UNITED STATES PATENT AND TRADEMARK OFFICE

APPLICATION NO.	FILING DATE	FIRST NAMED INVENTOR	ATTORNEY DOCKET NO.	CONFIRMATION NO.
10/711,640	09/29/2004	Basanth Jagannathan	FIS920040085	5639
45988	7590	09/20/2006	EXAMINER	
GREENBLUM & BERNSTEIN, P.L.C. 1950 ROLAND CLARKE PLACE RESTON, VA 20191			NGUYEN, TRAM HOANG	
			ART UNIT	PAPER NUMBER
			2818	
DATE MAILED: 09/20/2006

<b>Office Action Summary</b>	<b>Application No.</b>	<b>Applicant(s)</b>	
	10/711,640	JAGANNATHAN ET AL.	
	<b>Examiner</b>	<b>Art Unit</b>	
	Tram H. Nguyen	2818

### DETAILED ACTION

**FIG. 1H**

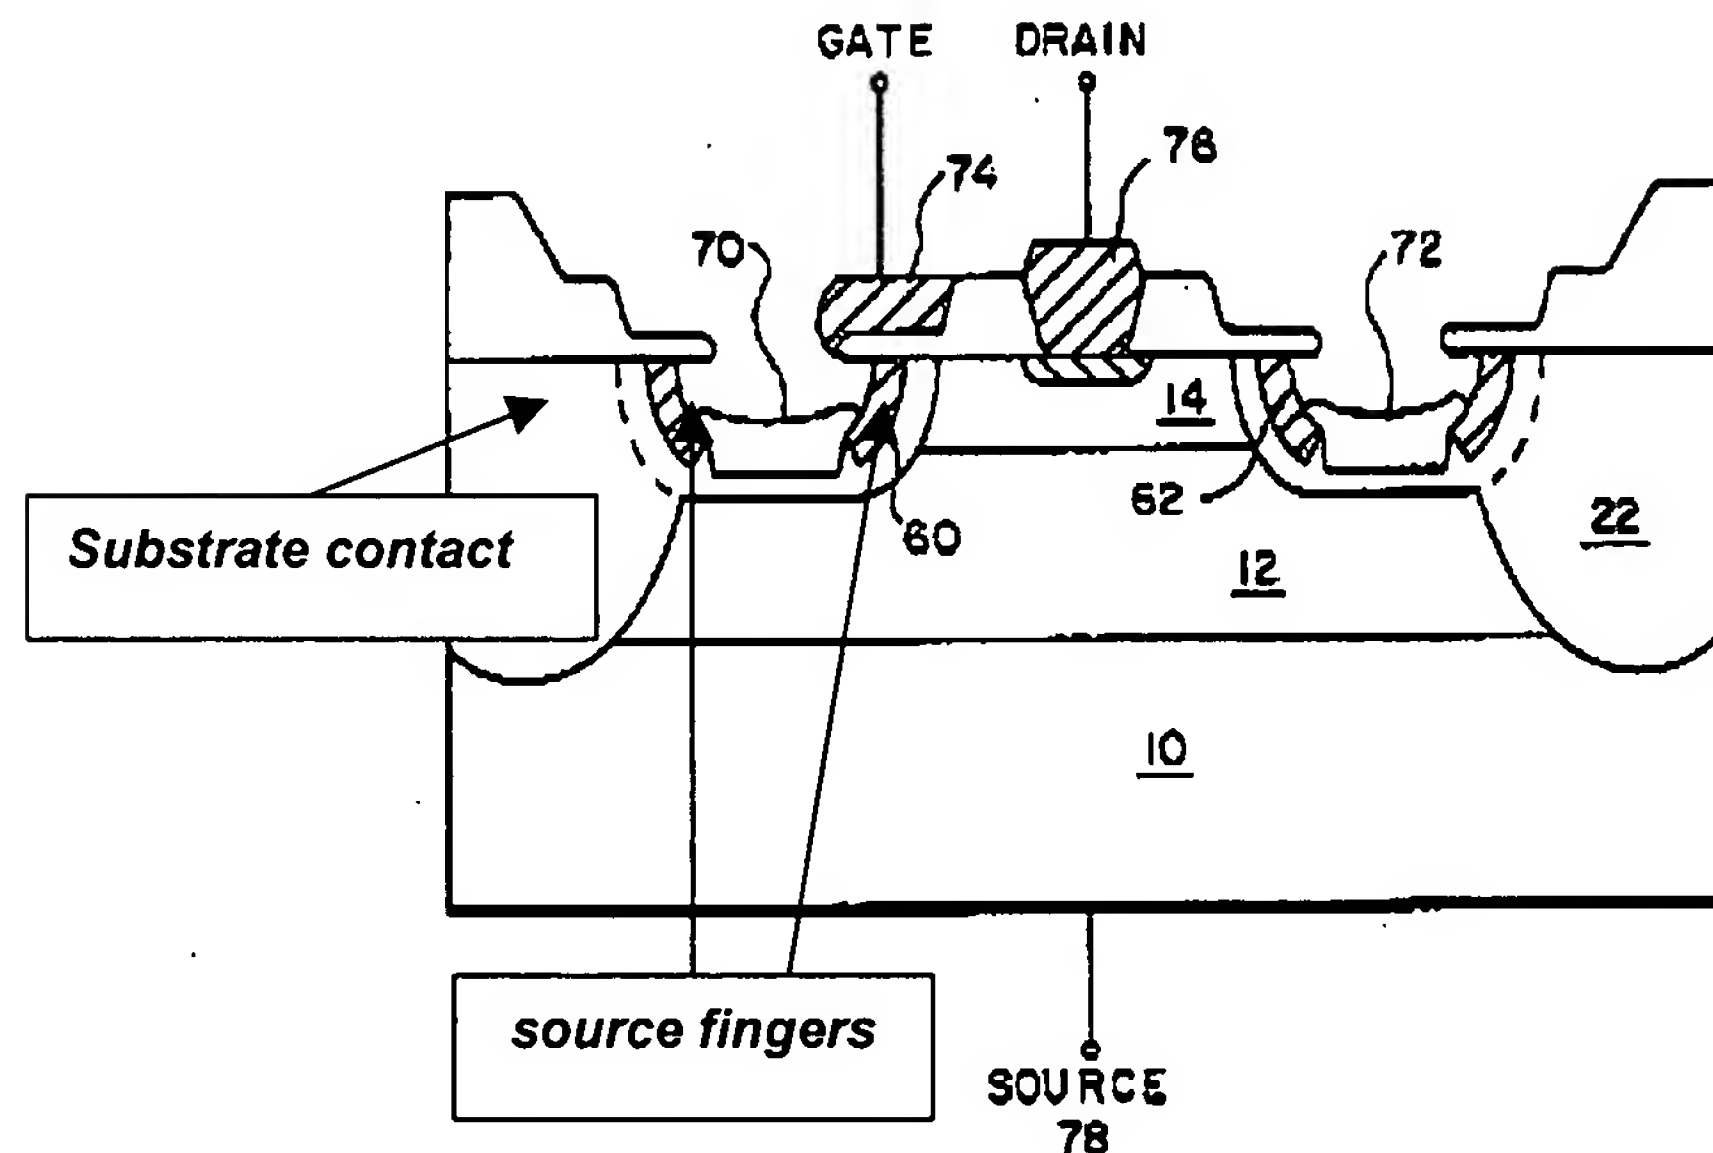
Regarding **claim 18**, Herzum discloses all the limitation of the claimed invention for the same reasons are set-forth above except for not explicitly teach the source comprises a source finger and the substrate contact abuts substantially all of one side of the source finger. However, Rice has a similar structure (fig. 1H) (Note: the current flows through the substrate contact (described in col. 4, lines 36-38)) wherein the source comprises a source finger and the substrate contact (reference numeral 20) abuts all of one side of the source finger (reference numeral 60) (col. 4, line 19). Therefore, it would have been obvious at the time the invention was made to a person having ordinary skill in the art to provide a source direct source to substrate contact in order to reduce expensive packaging techniques, further reduce output capacitance, and to reduce or eliminate junction capacitance (col.1, lines 56-59).

Regarding **claim 19**, Herzum and Rice disclose all the limitations of the claimed invention for the same reasons are set-forth above; likewise, Rice also teaches two source fingers arranged within substrate, wherein the substrate contact abuts two of the two source fingers (refer the above fig. 1H).

Regarding **claim 31**, Herzum discloses all the limitations of the claimed invention for the same reasons as set-forth above except for not explicitly show the substrate contact at least one of completely encircles an active region; almost completely encircles an active region; encircles three-quarters of an active region; and encircles half of an active region. However, Rice has a similar structure (fig. 1H) (Note: the current flows through the substrate contact (described in col. 4, lines 36-38)) wherein the substrate contact (reference numeral 20/22) at least completely encircles an active region (col. 2, lines 46-49). Therefore, it would have been obvious at the time the

Regarding **claim 32**, Herzum discloses all the limitations of the claimed invention for the same reasons as set-forth above except for the semiconductor device comprises an FET prime cell. However, Rice has a similar structure (fig. 1H) (Note: the current flows through the substrate contact (described in col. 4, lines 36-38)) wherein comprises an FET prime cell (Title). Therefore, it would have been obvious at the time the invention was made to a person having ordinary skill in the art to provide a source direct source to substrate contact in order to reduce expensive packaging techniques, further reduce output capacitance, and to reduce or eliminate junction capacitance (col.1, lines 56-59).

**FIG. 1H**

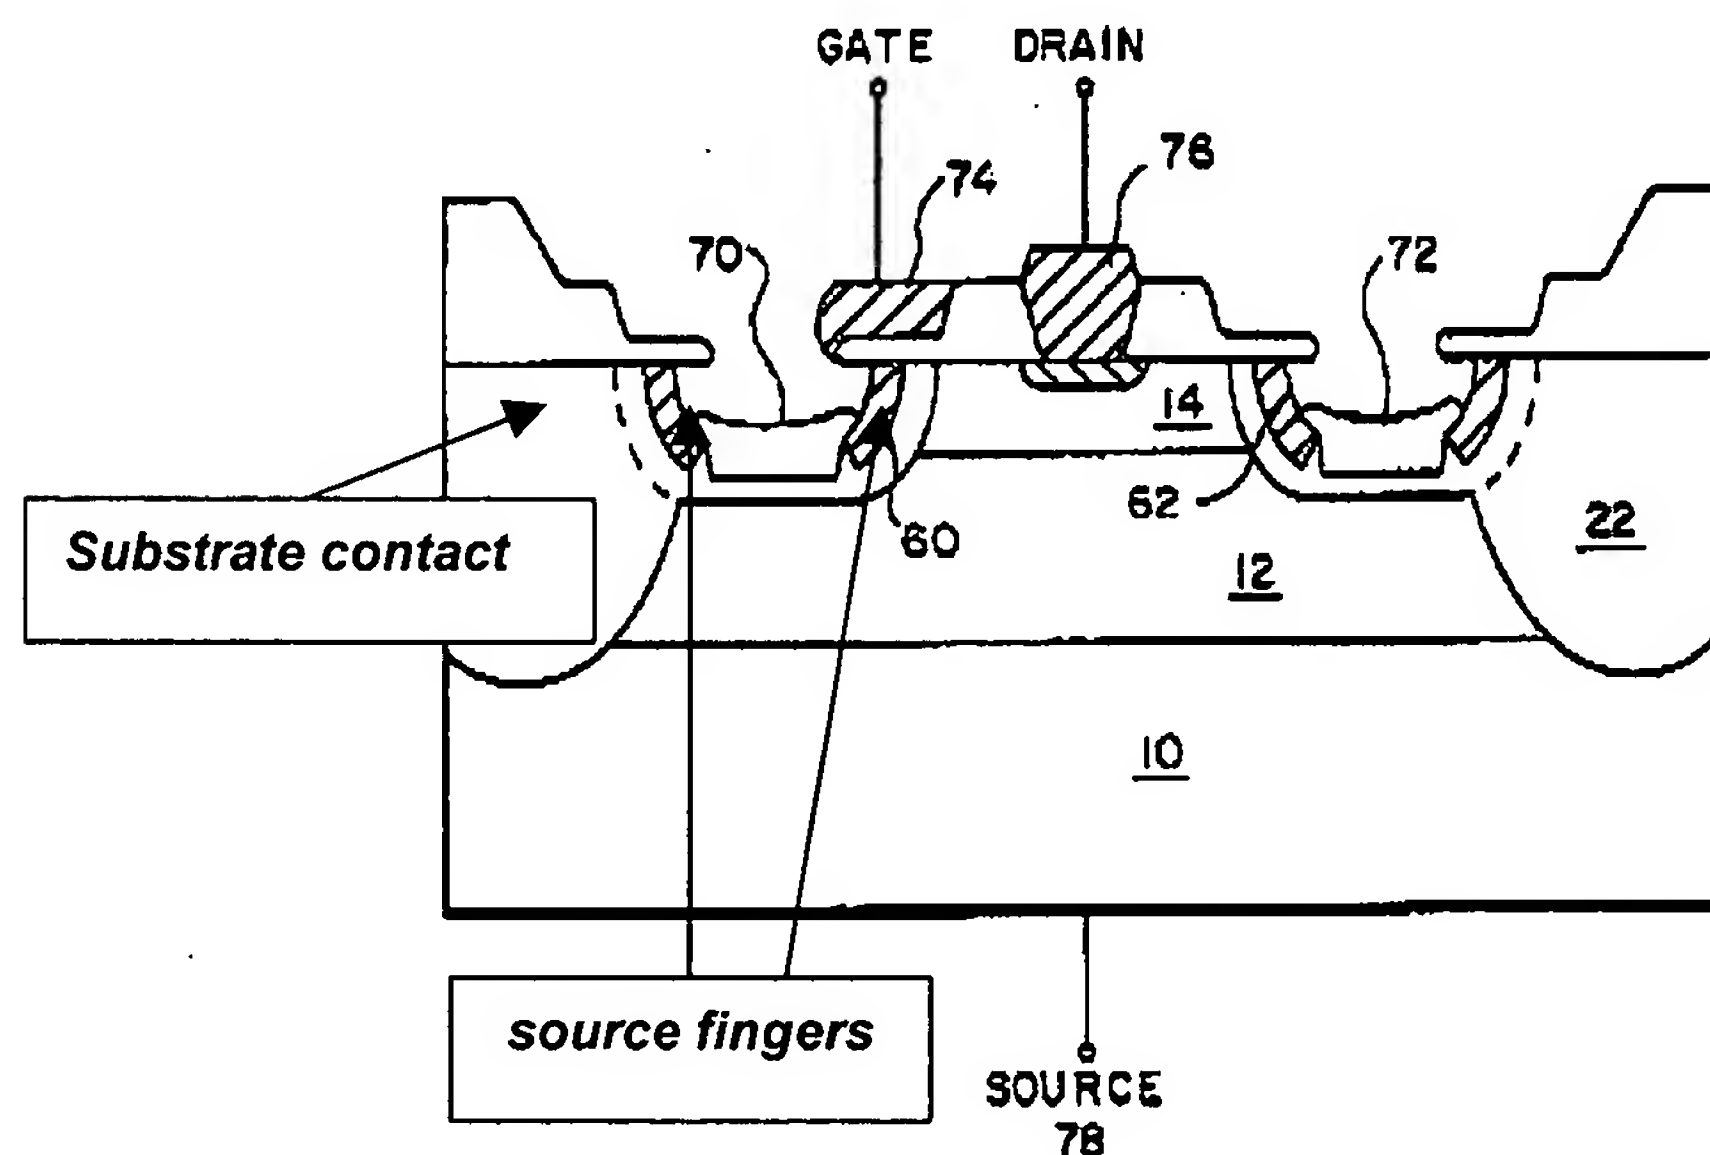
Regarding **claim 37**, Herzum discloses all the limitation of the claimed invention for the same reasons are set-forth above except for not explicitly teach the source comprises a source finger and the substrate contact abuts substantially all of one side of the source finger. However, Rice has a similar structure (fig. 1H) (Note: the current flows through the ring substrate contact (described in col. 4, lines 36-38)) wherein the source comprises a source finger and the ring substrate contact (reference numeral 20)

abuts all of one side of the source finger (reference numeral 60) (col. 4, line 19).

Regarding **claim 38**, Herzum and Rice disclose all the limitations of the claimed invention for the same reasons are set-forth above; likewise, Rice also teaches two source fingers arranged within substrate, wherein the substrate contact abuts two of the two source fingers (refer the above fig. 1H).

Regarding **claim 40**, Herzum discloses all the limitations of the claimed invention for the same reasons as set-forth above except for the semiconductor device comprises an FET prime cell. However, Rice has a similar structure (fig. 1H) (Note: the current

Regarding **claim 41**, Herzum discloses all the limitations of the claimed invention for the same reasons as set-forth above except for not explicitly show the substrate contact at least one of completely encircles an active region; almost completely encircles an active region; encircles three-quarters of an active region; and encircles half of an active region. However, Rice has a similar structure (fig. 1H) (Note: the current flows through the substrate contact (described in col. 4, lines 36-38)) wherein the substrate contact (reference numeral 20/22) at least completely encircles an active region (col. 2, lines 46-49). Therefore, it would have been obvious at the time the invention was made to a person having ordinary skill in the art to provide a source direct source to substrate contact in order to reduce expensive packaging techniques, further reduce output capacitance, and to reduce or eliminate junction capacitance (col.1, lines 56-59).
